**U.S. Army Corps of Engineers Information Needs – June 2009**

**Preparation for Bellefonte Units 3 and 4 Corps of Engineers Site Visit, July 8-10, 2009**

**COE INFORMATION NEED: COE-2**

#### COE INFORMATION NEED: COE-3

FIGURE 2.1-1  
 Site Plot Plan

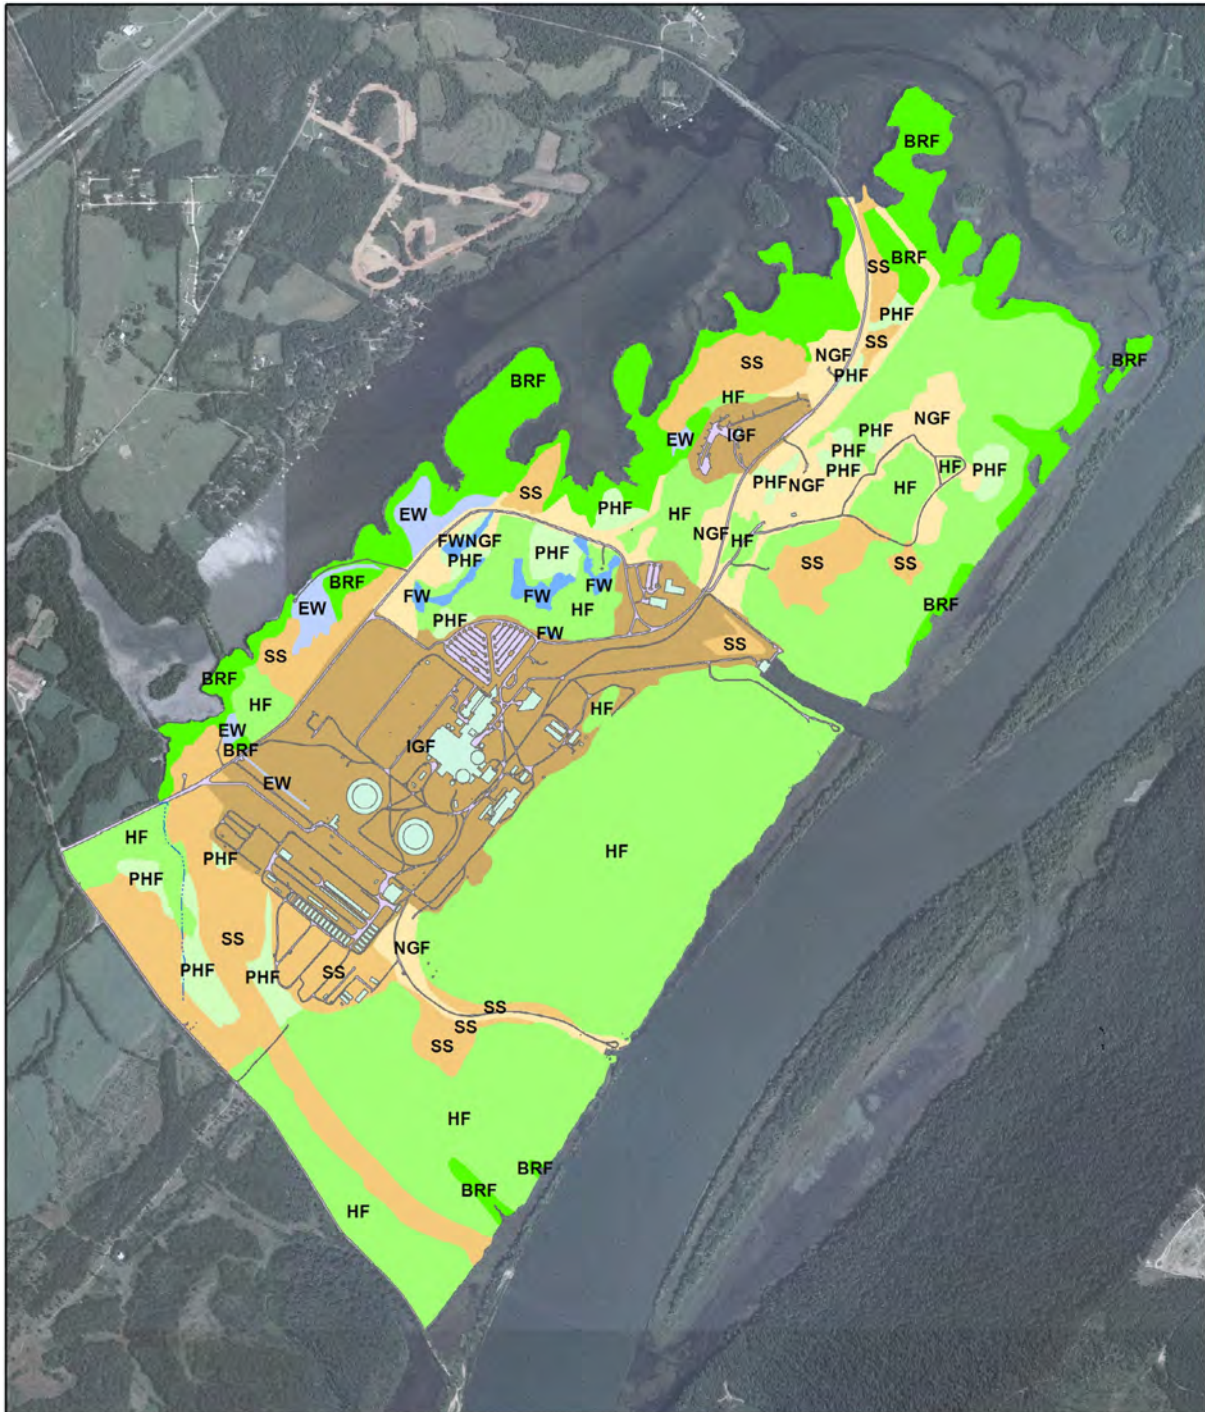
Provide an SME and supporting data and information to discuss plans for dredging or other activities to clean out barge slip and intake canal including alternative dredge methods, planned configurations and depths and frequency. Discussion should include:

- Discharge of dredged or fill material into wetlands or waterways,
- dredging performed during construction of Units 1 and 2 including mussels and aquatic organisms observed,
- alternative dredge material disposal sites, recycle options, and treatment/reuse alternatives,
- methods to minimize dredging and construction related turbidity.

BLN ER Figure 2.1-1, Site Plot Plan, illustrates the location of the intake canal, barge dock, and blowdown discharge.

**FIGURE 2.4-1**  
**BLN Vegetation Coverage**

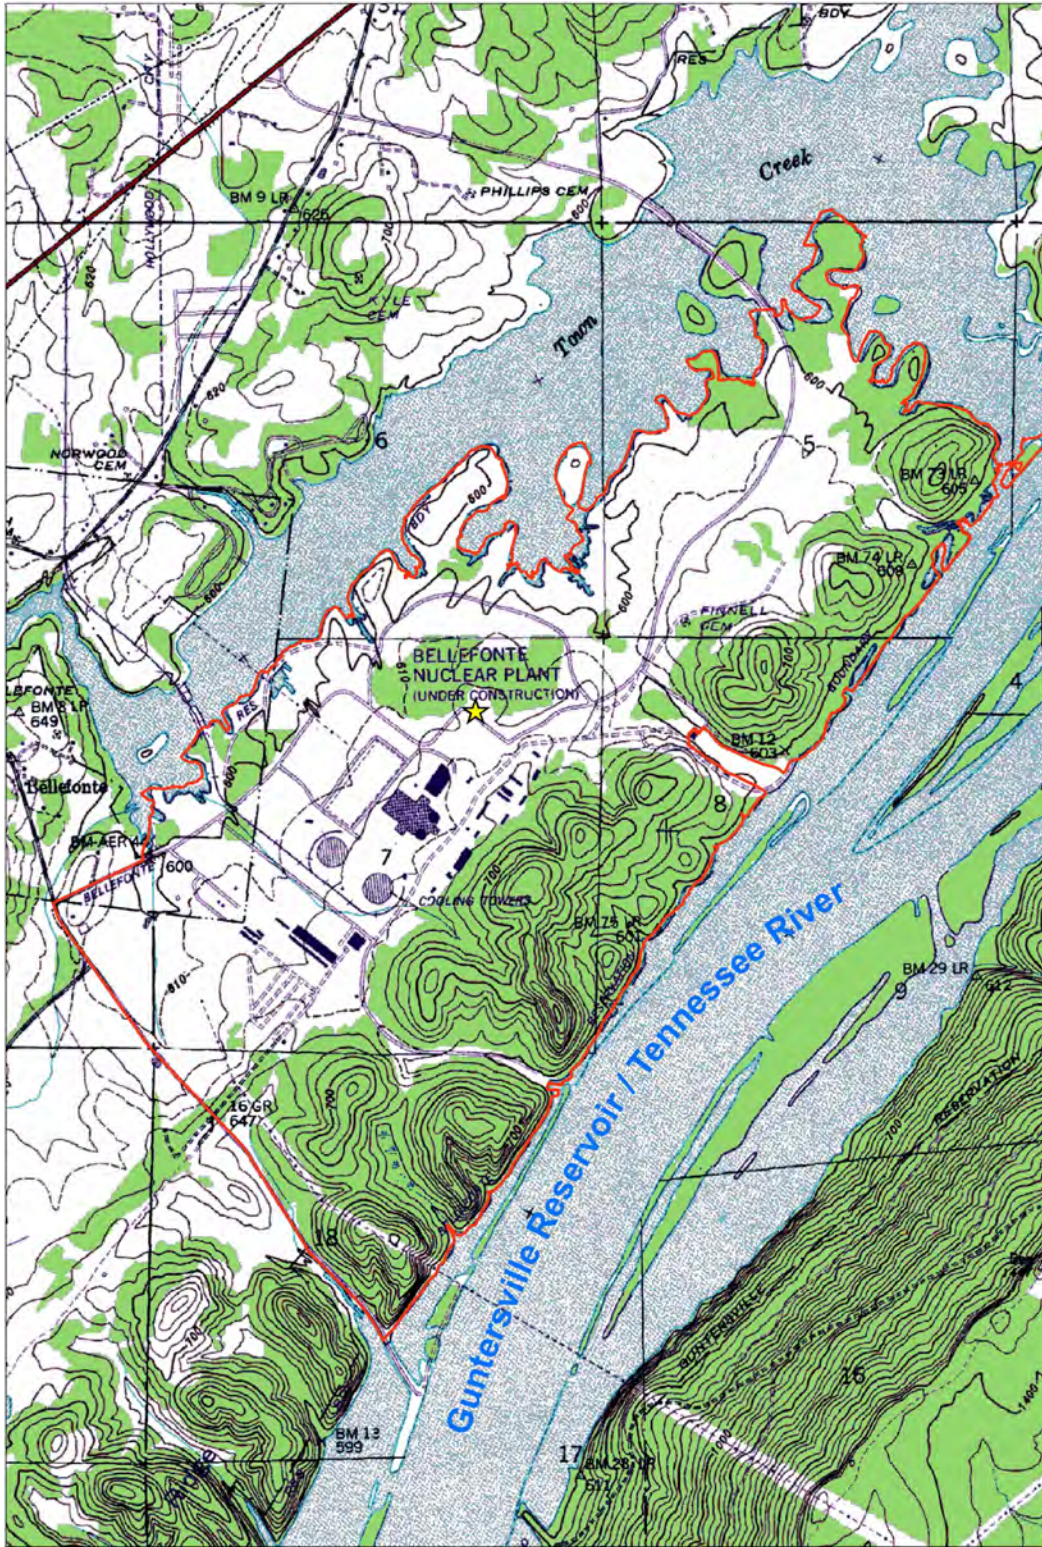
Provide an SME to discuss the wetland investigations that have been performed at the site and be prepared to discuss topics such as:

- Has the entire site been surveyed,
- wetlands found on the site both in the proposed construction foot print and in areas outside the footprint,
- how the recommendations of the May 2006 report (Request #10389 – Bellefonte NP – Wetlands Site Visit: Wetland Input) were investigated and considered in the on site alternatives analysis for construction of Bellefonte Units 3 and 4 for avoidance and minimization of environmental impacts,
- the process TVA has used to demonstrate that the locations selected for BLN units 3 and 4 are the least environmentally damaging practicable alternative (LEDPA), and that other site configurations would result in greater damage
- why the proposed units cannot be situated outside wetlands.

Provide maps of the survey areas to support the discussion.

Figures 2.4-1 (BLN Vegetation Coverage), 2.4-2 (BLN Topographic Map), and 2.4-3 (BLN Special Habitats) illustrate wetland areas and site topography, and are provided as attachments.
